Site Assessment

Hereford Point

Roman Road, Hereford HR4 9QP

Reviewed - 21-08-2024

1.3 Reinforcement and concrete placement

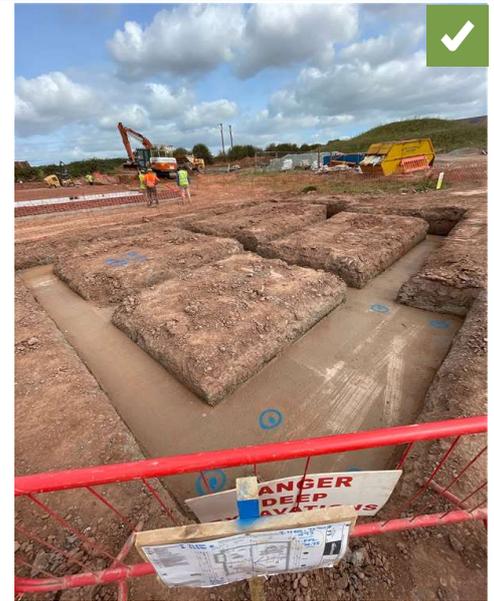
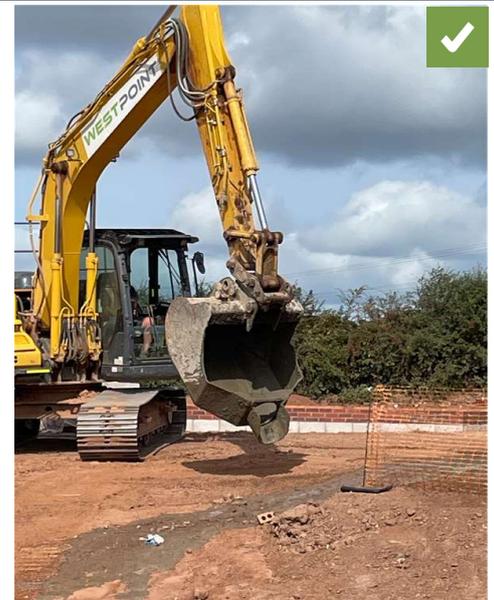
- 1 plot was available and viewed at this build stage, plot 493.
- Component/product/material details: Foundations / Trench fill / concrete placement.
- Contractor details: Westpoint (Groundwork contractors).
- Quality was very good and consistent across the plot seen.

- Quality control documentation was completed and viewed.
- Drawings and details were available to view on site.
- Placement of concrete was accurate with minimal overspill.
- Excavation corners were neatly formed.
- The concrete finish was consistent in texture and appearance.
- Setting out pins/paint were used to achieve line and level.
- Task specific funnel bucket used to avoid concrete overspill.

2.1 Walls and columns

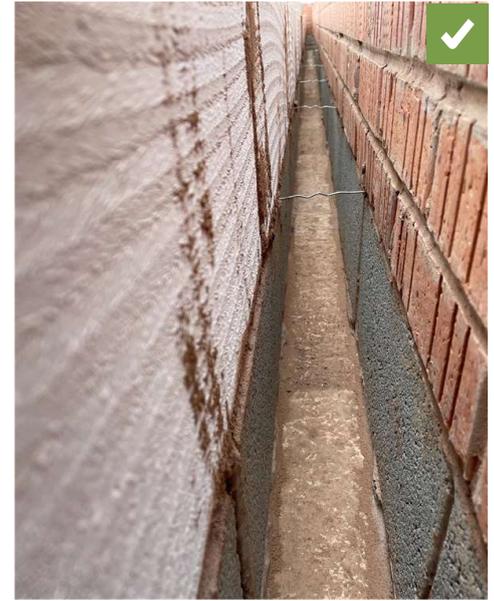
- Multiple plots were available with 2 viewed at this build stage, plots 494 & 495.
- Component/product/material details: Foundation blockwork / Splash course / Cavities.
- Contractor details: Westpoint (Groundwork contractors).
- Quality was very good and consistent across the plots seen.

- Quality control documentation was completed and viewed.
- A good line and level to the masonry had been achieved.
- Bed and perp joints were fully filled.
- Bond was correctly maintained.
- Frogs in the brickwork were filled with mortar.
- The cavities viewed were clean and free from debris.
- The internal face of the masonry was pointed.
- Wall ties were correctly spaced not exceeding 900mm horizontally.
- Cavity infill was neatly placed and chamfered to the outside face.
- Wall ties were at 90 degrees to the face of the masonry.

2.4 Ground floor

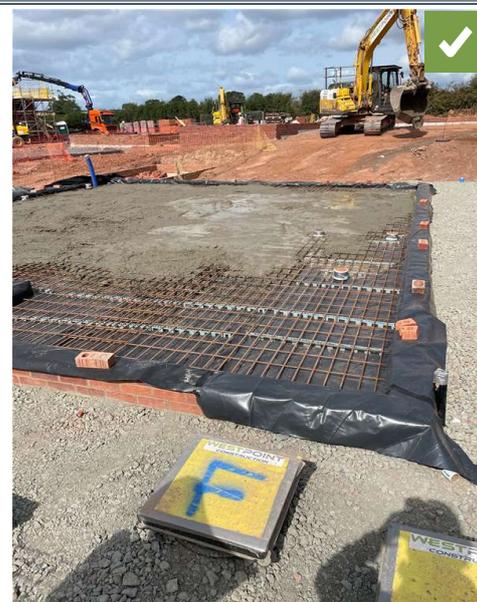
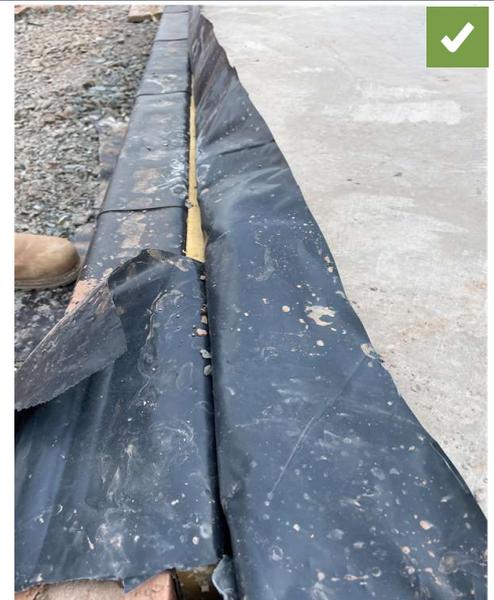
- Multiple plots were available with 3 viewed at this build stage, plots 489-490 & 492.
- Component/product/material details: Suspended ground floor / cast-in-situ / Insulation.
- Contractor details: Westpoint (Groundwork contractors).
- Quality was good and consistent across the plots seen.

- Quality control documentation was completed and viewed.
- Task specific funnel bucket used to avoid concrete overspill.
- 40mm minimum cover to reinforcement achieved where using a DPM.
- Reinforcement and mesh were appropriately supported, overlapped, and secured.
- The completed floor was level with a suitable finish.
- Thermal break had been provided to doorways.
- Thermal break had been provided to perimeter of floor.

2.5 Drainage (internal and external)

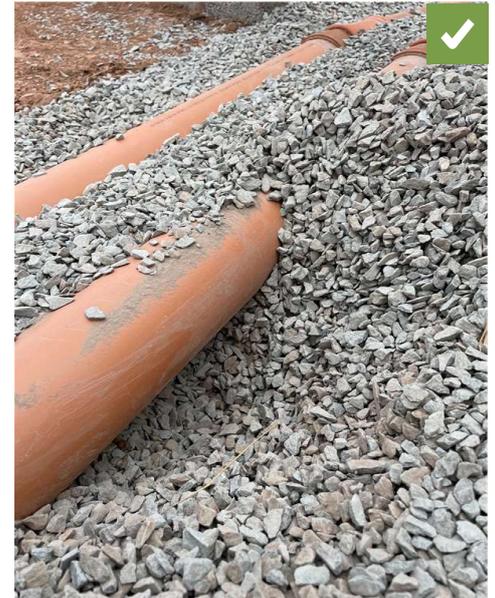
- Multiple plots were available with 2 viewed at this build stage, plots 494 & 495.
- Component/product/material details: Subfloor drainage / Inspection chambers.
- Contractor details: Westpoint (Groundwork contractors).
- Quality was outstanding and consistent across the plots seen.

- Good presentation of the completed works was achieved without the wastage of imported materials (ie. Sand).
- All open ends of drainage were capped off.
- All pipe runs were clearly labelled.
- Support of pipework had been provided with appropriate falls.
- The granular bedding to support drainage was a minimum of 100mm in depth.
- Support had been provided to internal rest bends.
- DPC was installed as a slip plane between the concrete, walls and other pipes to mitigate heave or ground movement.
- Flexible joints were installed, ensuring centres to collars were within 150mm of the wall and 600mm of the first collar.
- Penetrations had been closed to prevent vermin entry.

3.1 Structural frame and/or loadbearing walls

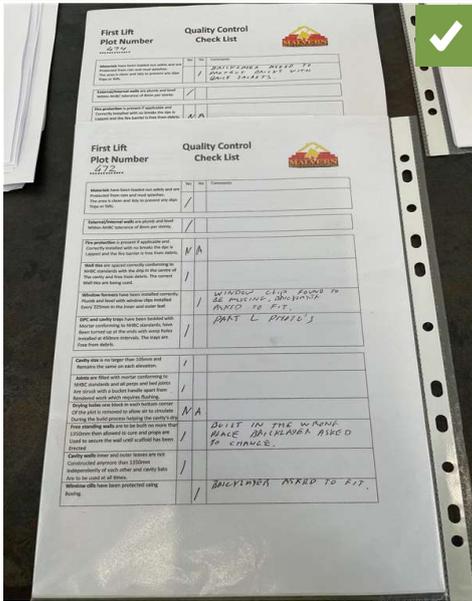
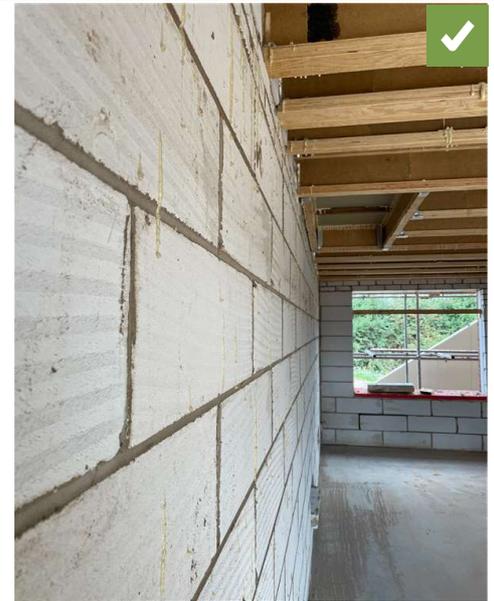
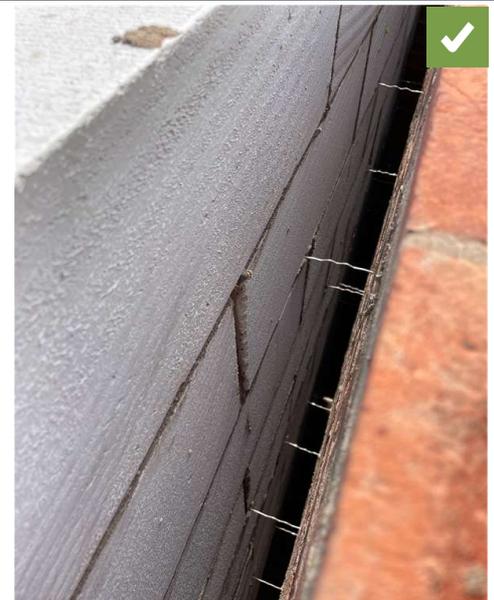
- Multiple plots were available with 1 viewed at this build stage, plot 482.
- Component/product/material details: Traditional cavity wall / Inner leaf blockwork (Aircrete).
- Contractor details: Malvern Brickwork (Bricklaying contractor).
- Quality was very good and consistent across the plot seen.

- Quality control documentation was completed and viewed.
- A good line and level to the blockwork was achieved.
- Bed and perp joints had been pointed.
- Bed and perp joints were even and fully filled.
- Coursing blocks were installed to achieve correct setting out.
- Blocks between joist were neatly cut and pointed.
- The cavity side of the block work had been neatly pointed.

3.2 External envelope including chimneys and flues

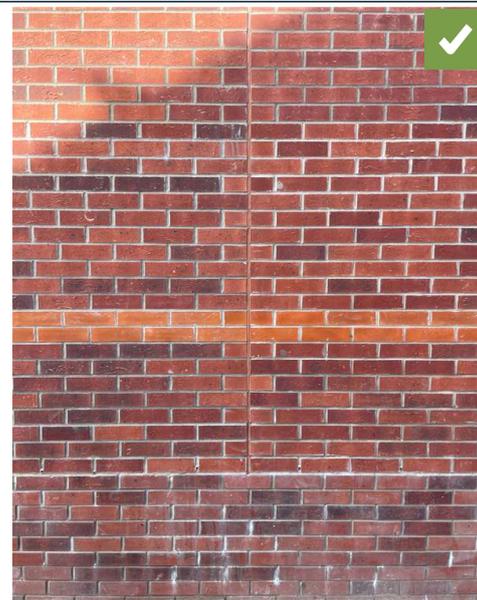
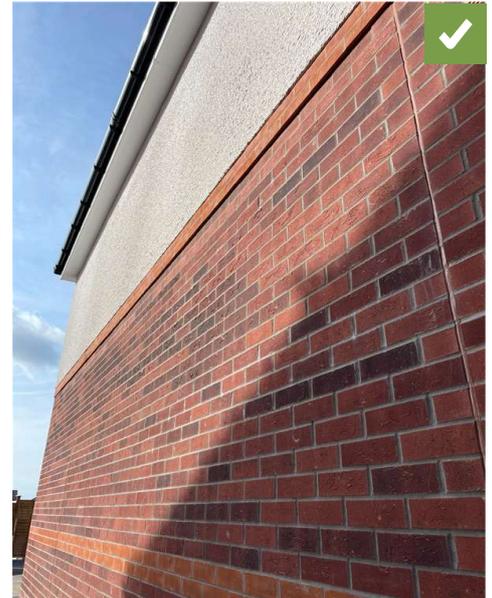
- Multiple plots were available with 9 viewed at this build stage, plots 364, 365, 366-367, 368-369, 370 & 481-482.
- Component/product/material details: Traditional cavity wall / External leaf (Clay brick) / Render / Movement joints.
- Contractor details: Malvern Brickwork (Bricklaying contractor).
- Quality was outstanding and consistent across the plots seen.

- Masonry was completed to a good line and level, without excessive deviation from the vertical plane.
- Bed and perpend joints were fully filled to the masonry structure.
- Bed and perpend joints were in line.
- Corbelling to the masonry did not exceed more than a third of the size of the unit.
- Masonry was uniform in colour, without excessive banding.
- Window and door openings were square without excessive tolerances.
- The cavity side of the brickwork had been neatly pointed.
- Meter boxes were protected during construction.

3.3 Cavities, insulation and soundproofing

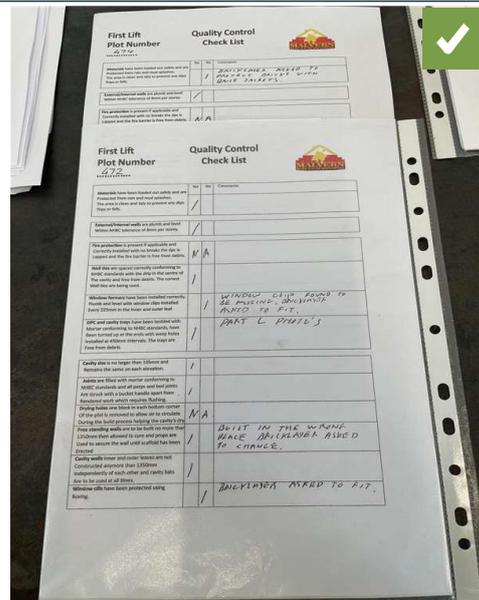
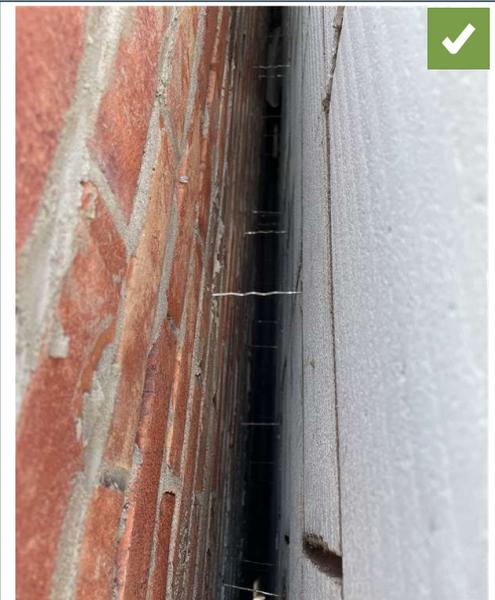
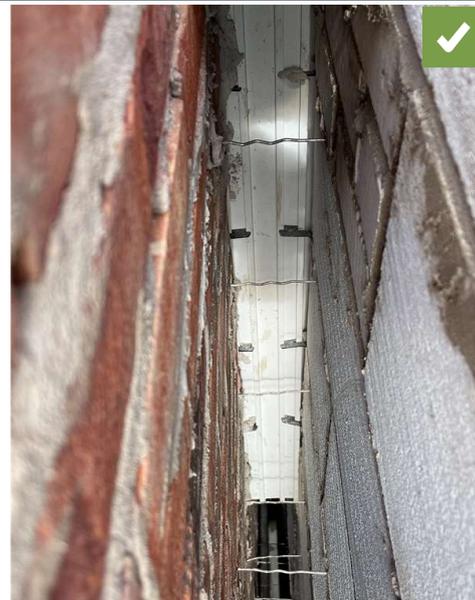
- Multiple plots were available with 2 viewed at this build stage, plots 481-482.
- Component/product/material details: Traditional cavity wall / Wall ties / Cavity Closers / Insulation (Blown).
- Contractor details: Malvern Brickwork (Bricklaying contractor).
- Quality was very good and consistent across the plots seen.

- Quality control documentation was completed and viewed.
- Cavities were clean and free from debris.
- Wall ties were neatly laid at 90 degrees to the face of the masonry.
- The cavities were built with uniform widths.
- General wall ties installed with a maximum spacing of 900mm horizontal and 450mm vertical centres.
- Window former ties were incorporated into the masonry at correct centres.
- Cavity closers were cut accurately and fitted tight into cavities.
- Wall ties were installed within 225mm horizontally and 300mm vertically of the opening.
- Separating wall ties were correctly installed as per Robust Details & Approved Document E with no more than 2.5 ties per m2.

3.4 DPCs and trays

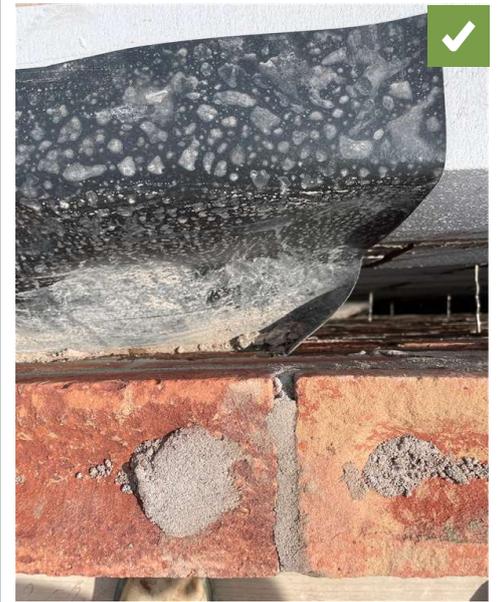
- Multiple plots were available with 3 viewed at this build stage, plots 370 & 481-482.
- Component/product/material details: Horizontal trays (flexible & preformed) / Weep holes.
- Contractor details: Malvern Brickwork (Bricklaying contractor).
- Quality was very good and consistent across the plots seen.

- Cavity trays were correctly positioned over all openings.
- Cavity trays were generally clean and free from debris.
- Both cavity tray ends correctly turned up a minimum of 75mm or in a full perpend joint.

3.6 Intermediate floor structure

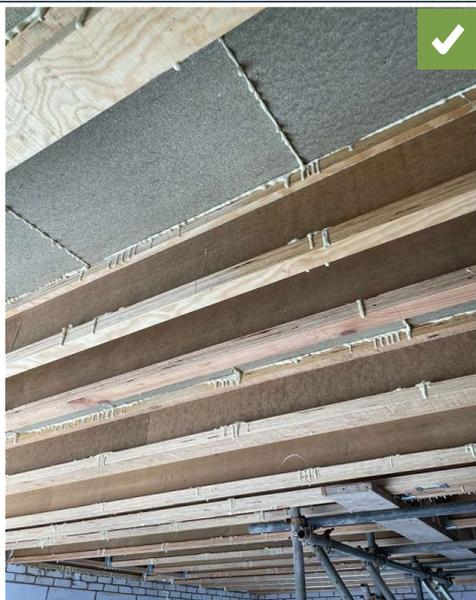
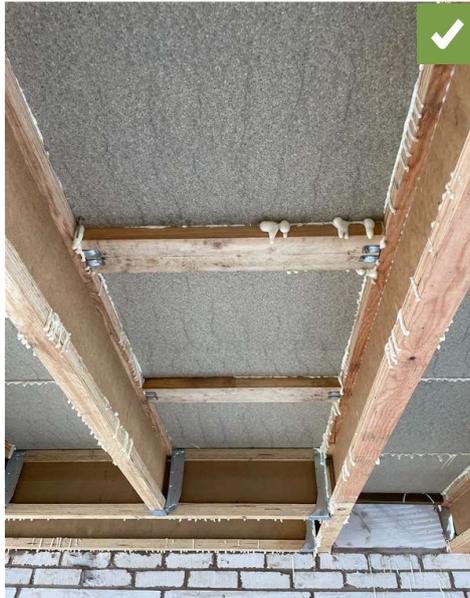
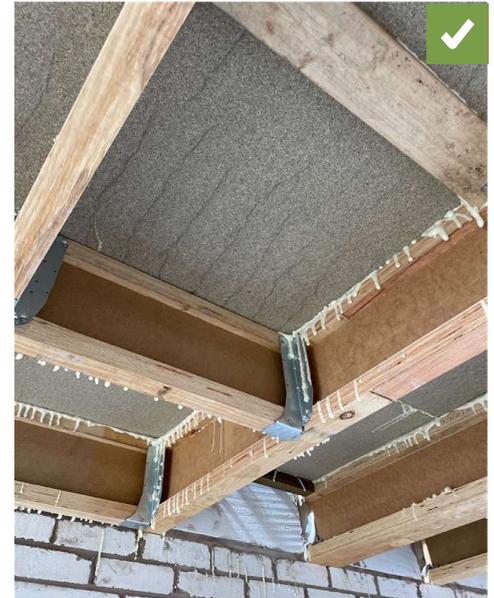
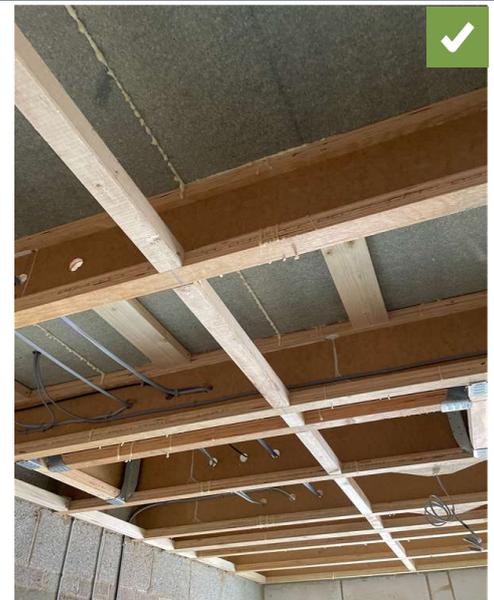
- Multiple plots were available with 3 viewed at this build stage, plots 481-482 & 545.
- Component/product/material details: Engineered I-Joists (Mon joists)
- Contractor details: Mike Lewis Carpentry (Carpentry contractor).
- Quality was outstanding and consistent across the plots seen.

- Joists were installed parallel and did not exceed 600mm centres.
- Adequate packing provided between the wall and the first joist directly under the restraint strap.
- Solid timber noggings, at least 0.5 times the joist depth, were installed directly under the restraint straps per the design.
- Support noggings were fitted to the underside of partition walls in accordance with the design.
- Joist hangers were fitted tightly around joists and fully nailed.
- Joists were seated correctly in hanger
- Perimeter noggings were installed in accordance with the design.
- Additional noggings were provided for plasterboard support to ceiling perimeters and ends of boards.

4.5 Flashings, gutters and downpipes

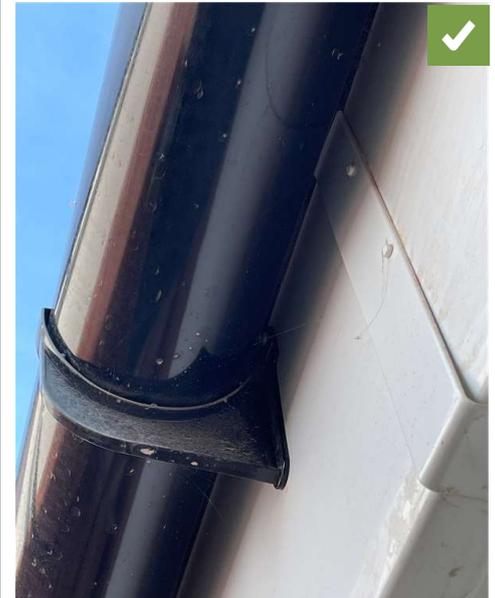
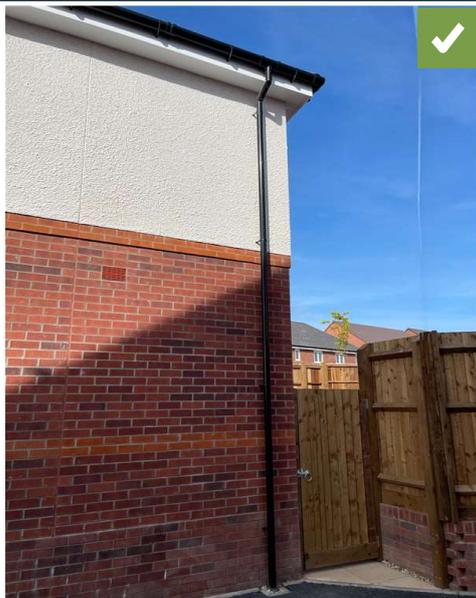
- Multiple plots were available with 7 viewed at this build stage, plots 364, 365, 366-367, 368-369 & 370
- Component/product/material details: PVC gutters and downpipes (Polypipe).
- Contractor details: Hamilton Thurston (Plumbing contractor).
- Quality was very good and consistent across the plots seen.

- Good support to gutters with evenly spaced brackets at correct centres.
- Correct screws used for gutter brackets.
- Downpipe brackets were installed not exceeding manufacturer's recommended vertical centres.
- Downpipes were installed consistently plumb.
- Dome head screws provided to all downpipe brackets.

5.1 Window and door frames

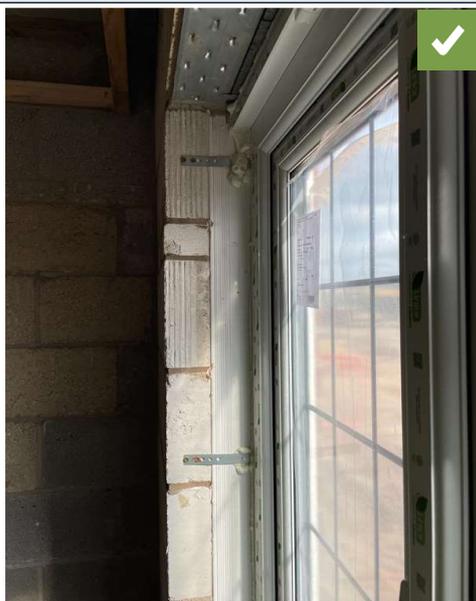
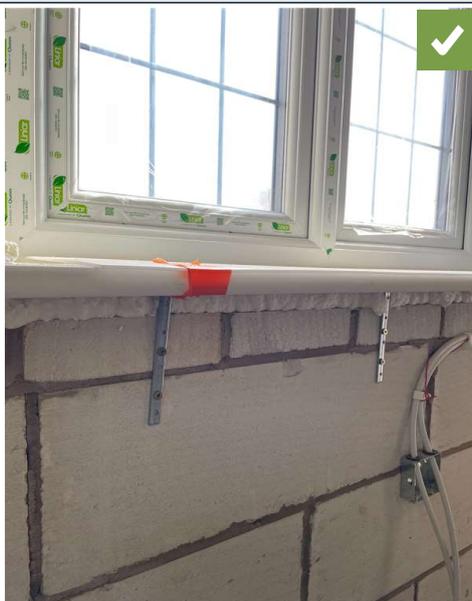
- Multiple plots were available with 2 viewed at this build stage, plots 370 & 545.
- Component/product/material details: uPVC windows (A&B Glass Group) / External composite doors (Vista Doors).
- Contractor details: A&B Glass Group (Supply & fit) / Lewis Carpentry Contractors (Entrance door installer).
- Quality was outstanding and consistent across the plots seen.

- Protection had been provided to the door leaves.
- Door thresholds were adequately protected.
- Door frames were precisely installed to ensure thermal continuity with the external walls.
- Proprietary washer head door fixings were used as per the specification.
- The door cills were reinforced using a proprietary steel support.
- Windows and doors were accurately positioned in their openings.
- Brackets to windows were fitted at max 600mm centres and 150mm from top and bottom of the frame.
- Brackets were aligned according to the manufacturer's specifications.
- Windows boards were securely fixed.

5.2 Floor decking, stairs and soundproofing

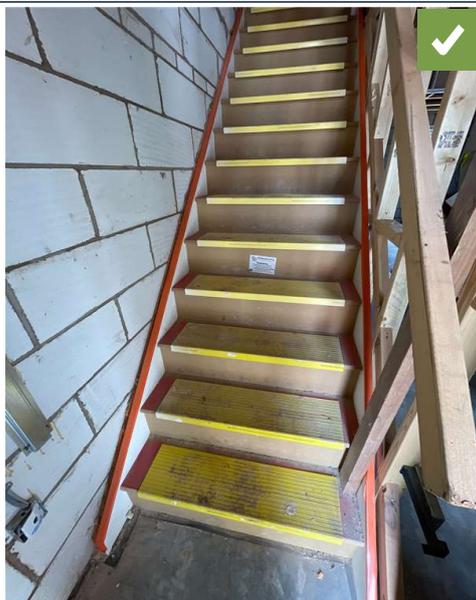
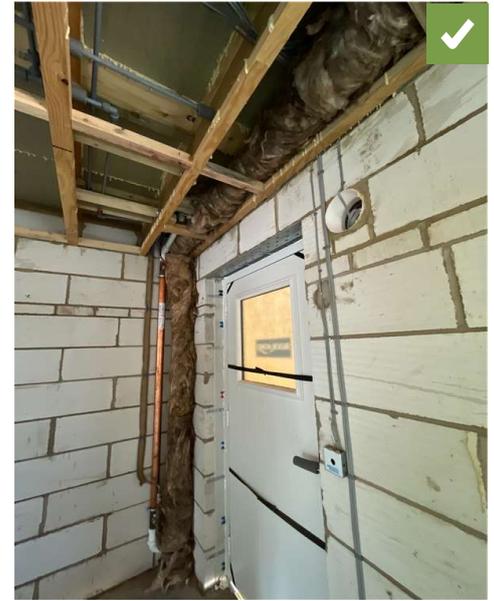
- Multiple plots were available with 2 viewed at this build stage, plots 482 & 545.
- Component/product/material details: Floor decking (CaberDek) / Timber stairs (GD Woodwork).
- Contractor details: Lewis Carpentry Contractors (Carpentry contractor).
- Quality was outstanding and consistent across the plots seen.

- Stair treads were adequately protected.
- Stair fixings installed through full length packer in line with BWF guidance.
- Staircases were installed in accordance with manufacturer's guidance / British Woodworking Federation.
- All stair treads and risers had been securely fixed with packers and wedges.
- Insulation installed below stairs to reduce sound transmission.
- Soil and waste pipes were insulated for sound.
- The adhesive completely filled the joints, and it was visible between the boards underneath the decking.

5.3 Services – electrical

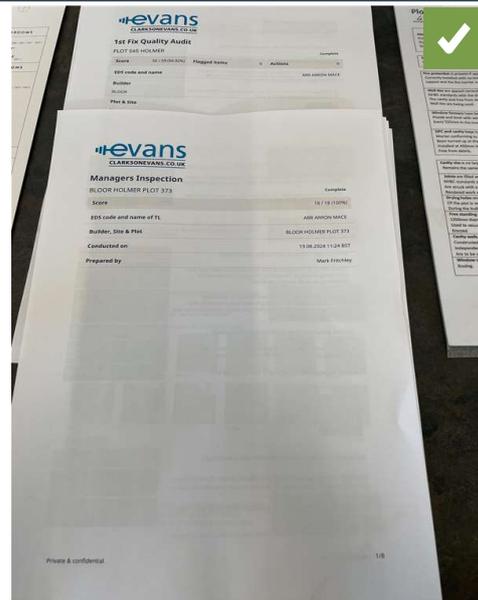
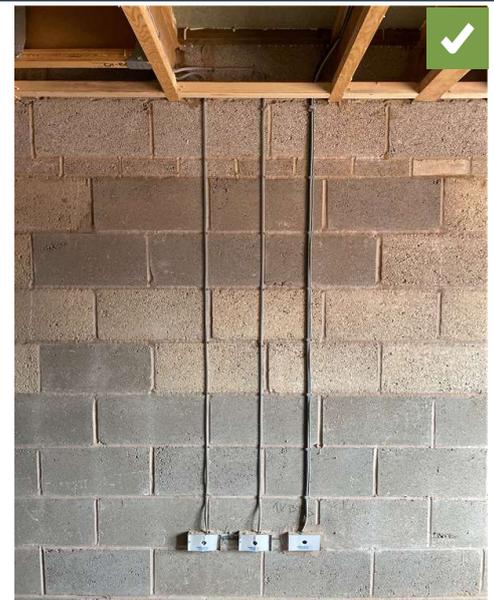
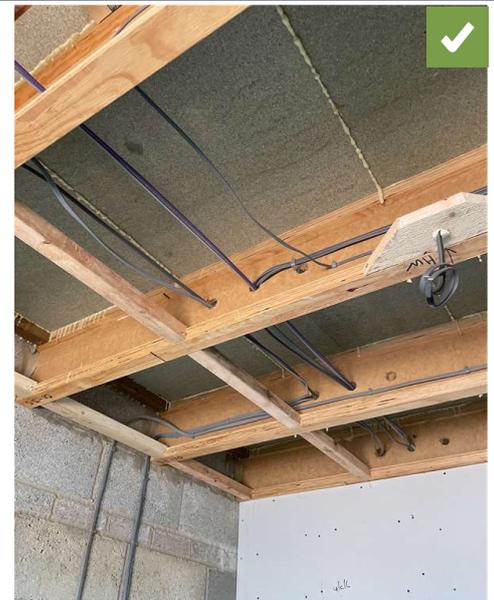
- 1 plot was available and viewed at this build stage, plot 545.
- Component/product/material details: Electrical supply & distribution / Cables / Back Boxes / Protection.
- Contractor details: Clarkson Evans (Electrical contractor).
- Quality was very good and consistent across the plot seen.

- Quality control documentation was completed and viewed.
- All cables were kept within safe zones in line with BS7671.
- All cables were neatly clipped with adequate support at the recommended centres.
- Protection was provided to incoming supply to consumer unit.
- Cable drops in studwork were pulled taut.
- Back boxes were protected with inserts.
- Good support provided with proprietary brackets.
- Cables achieved 50mm cover from the top or bottom of the joists.
- Cables passing through masonry leaves were protected by a sleeve.
- Cables were neatly clipped to the joists.
- Noggins / pattresses were provided for ceiling mounted items.
- Distribution cables were installed at least 25mm from gas pipework or separated by a non-conductive barrier as set out in BS 6891(1).
